## DEVELOPMENT APPLICATION ASSESSMENT REPORT

<b>Application Number:</b>	DA2019/1069
----------------------------	-------------

<b>Responsible Officer:</b>	Catriona Shirley
<b>Land to be developed (Address):</b>	Lot 4 DP 18667, 205 Riverview Road AVALON BEACH NSW 2107
<b>Proposed Development:</b>	Alterations and additions to a dwelling house including a swimming pool
<b>Zoning:</b>	E4 Environmental Living
<b>Development Permissible:</b>	Yes
<b>Existing Use Rights:</b>	No
<b>Consent Authority:</b>	Northern Beaches Council
<b>Delegation Level:</b>	DDP
<b>Land and Environment Court Action:</b>	No
<b>Owner:</b>	Kristen Rooney
<b>Applicant:</b>	Kristen Rooney

**Figure 1:** Building height non-compliance shown in pink.

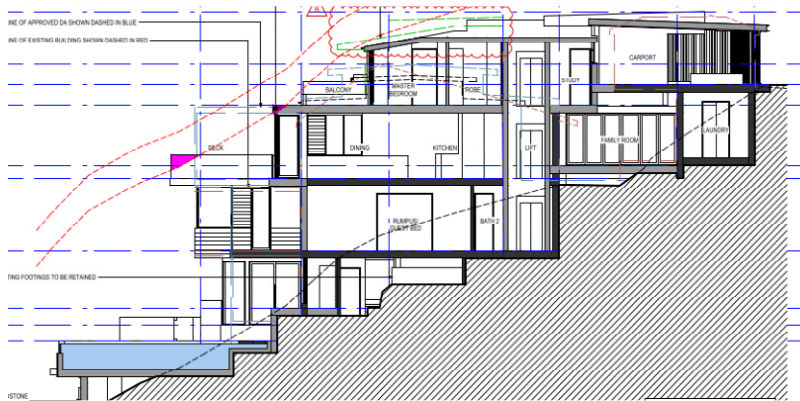
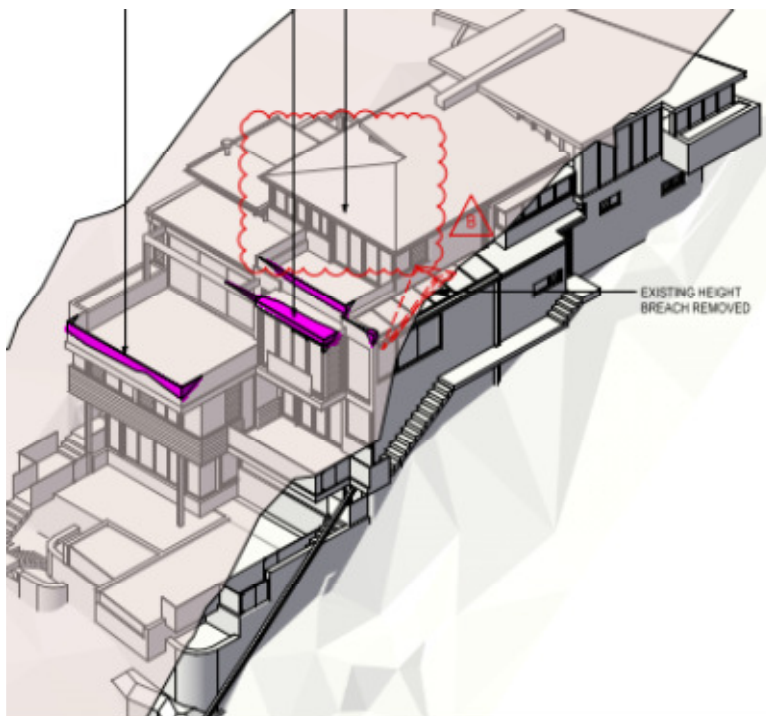
The building height non-compliance is demonstrated in figures 1 and 2 below.

The non-compliance is located at the western edge of the roofline and along the new terrace areas (demonstrated in figure 1 and 2 above) due to the topographical nature of the site. The non-compliance is considered to be relatively minor and does not unreasonably conflict with the height and scale of surrounding and nearby development. In this context, the proposed height non-compliance is considered to be compatible.

The portions of the development that exceed the 8.5m building height plane are limited in height and depth, as demonstrated in figure 1 and 2 above. The protrusions are reasonably described as minor.

**Figure 3. Extent of excavation shown red.**

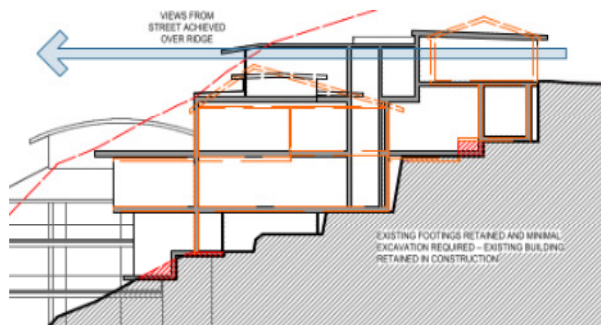
The proposal is reliant upon a minor volume of excavation under the footprint of the carport on the Ground Floor and under the footprint of the Lower Ground Floor for the proposed toilet and bathroom for the Pool Level as shown in figure 3. However, the visual impact of the minor excavation will be screened from view, and the proposal presents as a dwelling that has been sited to sympathetically follow the natural slope of the land.

**Figure 6:** The location of the lounge room below the Riverview Road street level.

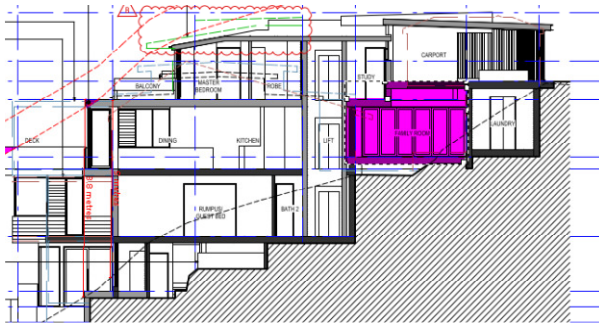
The proposed Lounge Room on Ground Level will be situated below street level as demonstrated within Figure 6 and 7 below. Therefore, the character of Riverview Road will remain unaffected by the built form of the Lounge Room.

**Figure 8:** Additional envelope breach on the northern elevation shown in green, existing envelope

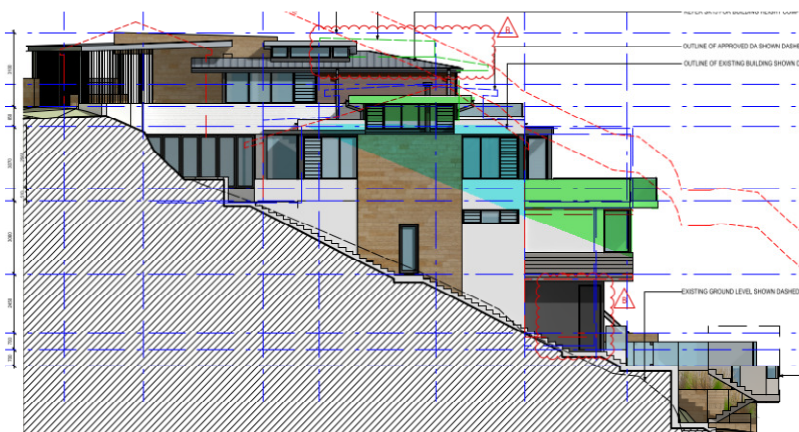
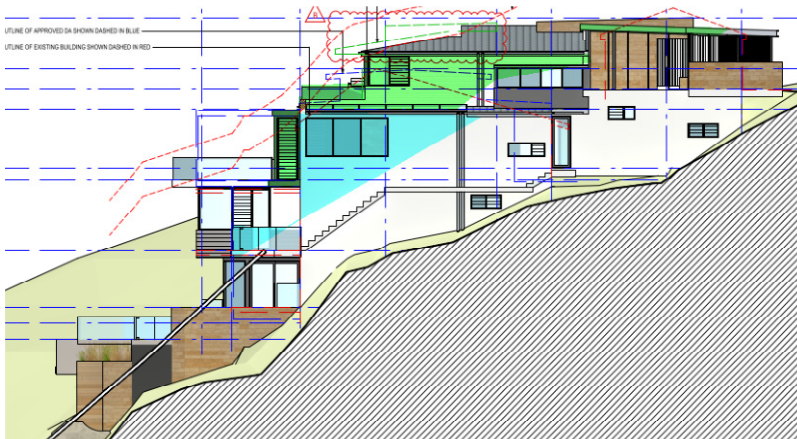
The existing dwelling includes non-compliance with the stated building envelope from the north to the north western corner and south to the south western of the upper level, caused by the significant slope of the site from front to rear. The proposed bedrooms of the lower ground floor of the dwelling are proposed to project further to the west, meaning that a further breach results. The proposed First Floor introduces a new non-compliance with the building envelope control, particularly on the southern elevation.

The figures below shows the location and extent of the non-compliance.

The facade of the dwelling on the north and south elevation is sufficiently modulated to respond aspect of the site and its steep slope. The resultant development is considered to be a sensitive design response in consideration of the natural characteristics of the site, with
